## **TILLMAN'S CORNER SOUTH SUBDIVISION**

APPLICATION NUMBER 4 DATE June 15, 2017

REQUEST Subdivision

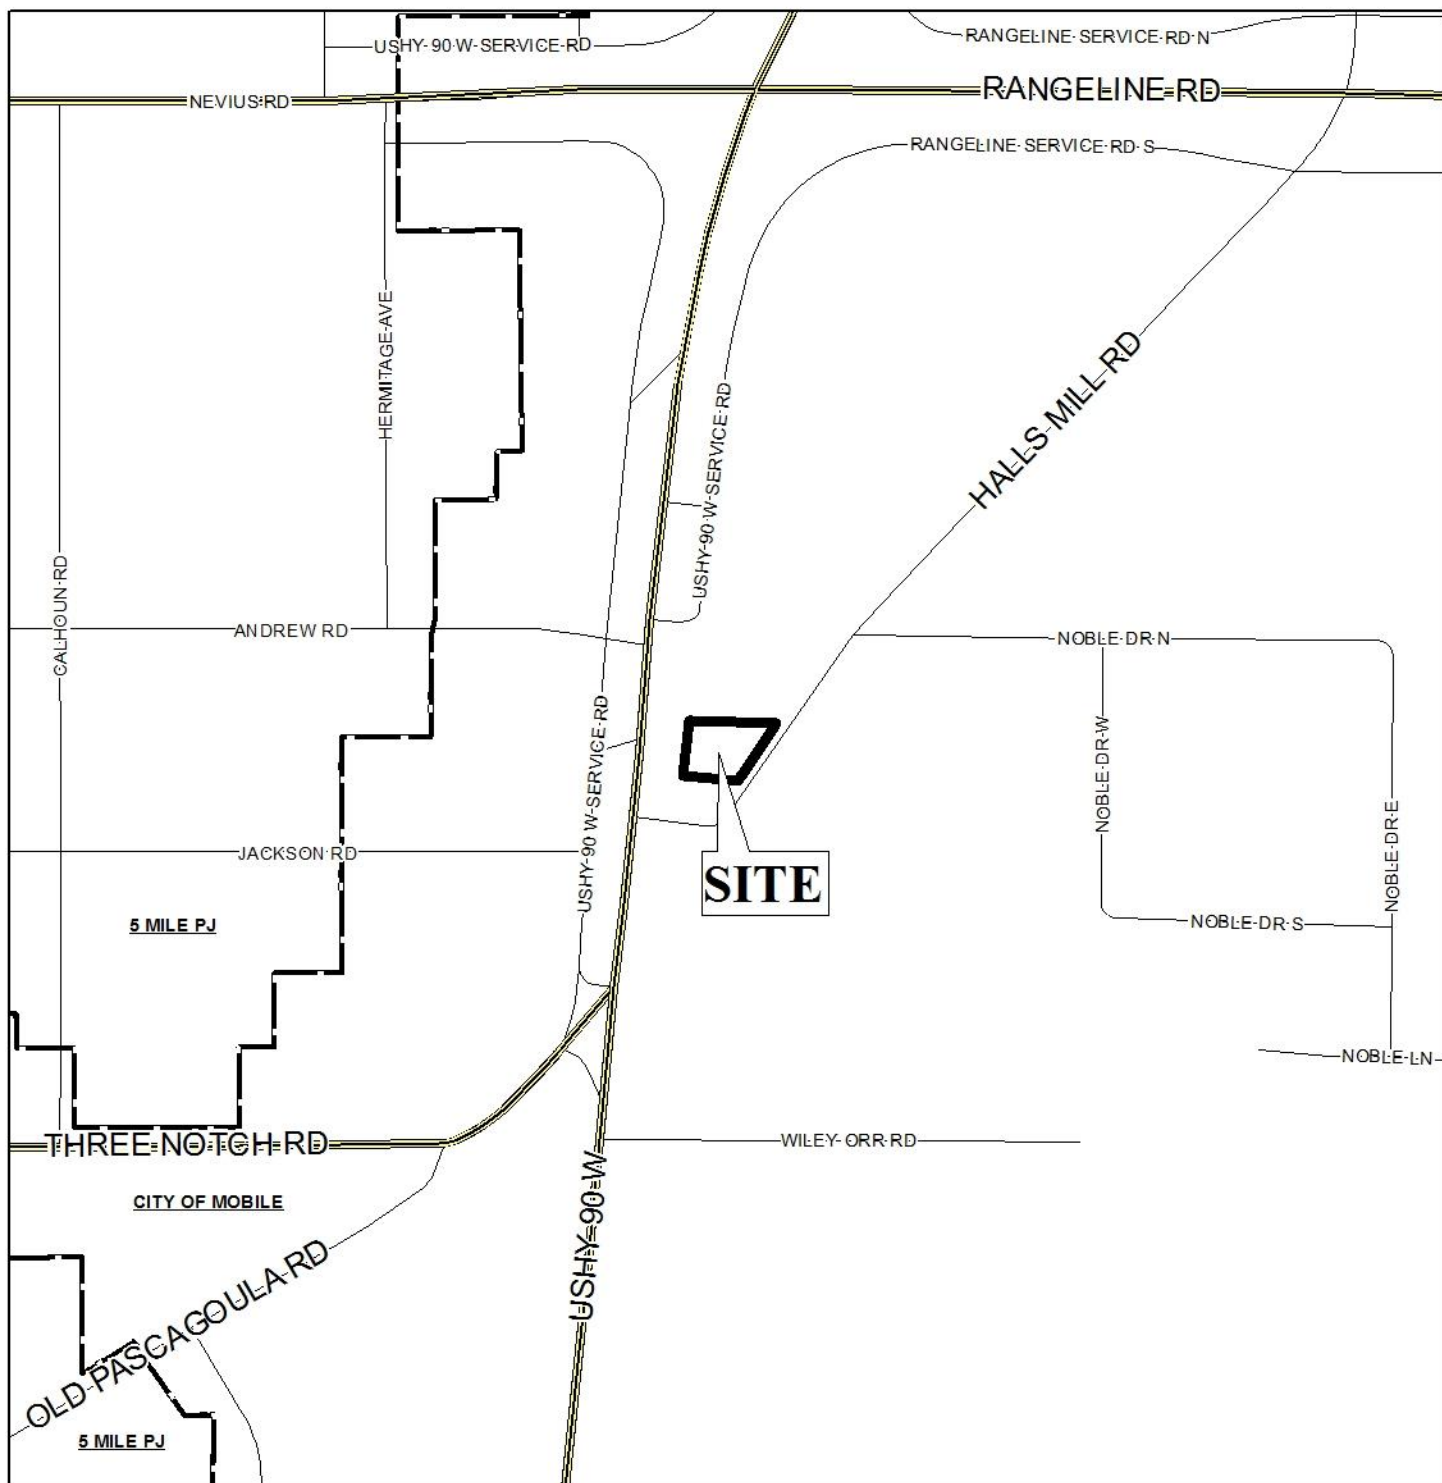
The lot size is labeled on the preliminary plat in square feet and acres, and should be retained on the Final Plat, if approved. It should be noted that the proposed lot would exceed the required lot size minimum in Section V.D.2. of the Subdivision Regulations.

The site has frontage along U.S. Highway 90 West and Halls Mill Road. U.S. Highway 90 West is an ALDOT controlled right-of-way and is a major street on the Major Street Plan, and as such requires a 250' right-of-way. The preliminary plat illustrates an existing right-of-way of 255', thus no dedication is required. Halls Mill Road is a Minor Arterial street in this area, and as such should have a 70' right-of-way. The preliminary plat illustrates an existing 50' wide right-of-way, making dedication to provide 35' from the centerline necessary.

# DETAIL SITE PLAN

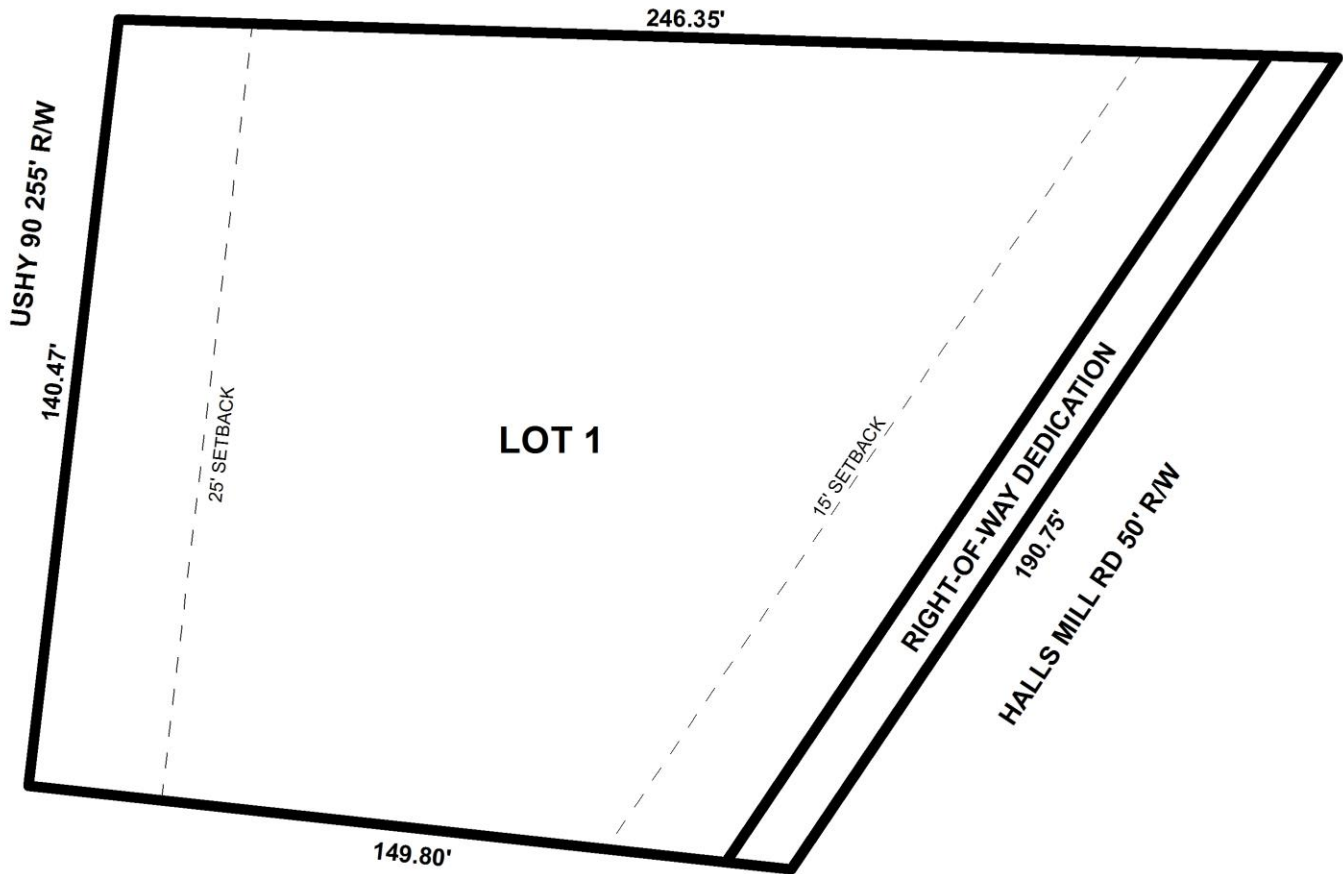
The purpose of this application is to amend a condition of approval on a previously approved 1-lot Subdivision. The previously approved subdivision required dedication to provide 35' from the centerline of Halls Mill Road, which is designated as a Minor Arterial, and a required 70 foot right-of-way. The applicant is now requesting a reduced setback to accommodate dedication. The subject site was included in a Subdivision application that was approved at the Planning Commission's March 9, 2017 and April 20, 2017 meetings. In both cases, the building setback lines were approved with a more stringent minimum building setback line than the applicant is now requesting. The most recent approval allowed for a 20' minimum building setback along Halls Mill Road, and the applicant now requests a 15' minimum building setback along Halls Mill Road. The applicant provided a site plan depicting the proposed layout of the site and as it is approved now, a portion of the dumpster enclosure and a portion of an overhead canopy would be within the setbacks. Therefore, the applicant is requesting a 15' minimum building setback in lieu of the 20' setback along Halls Mill Road, to eliminate the conflict between the proposed structures and the setbacks. The applicant also states that there is no room on the site to shift the items to avoid a setback compliance issue.

While an additional reduction in the required setback along Halls Mill Road would allow the development as proposed, it would also set a precedent for other properties along this segment of Halls Mills Road to make similar request. The Planning Commission should consider the possibility that the applicant is simply proposing to develop the site in a manner that does not comply with the regulations. Also, it should be noted that a variance request will also be required to address setbacks required by the Zoning Ordinance, for both the request at hand as well as the most recently approved request.
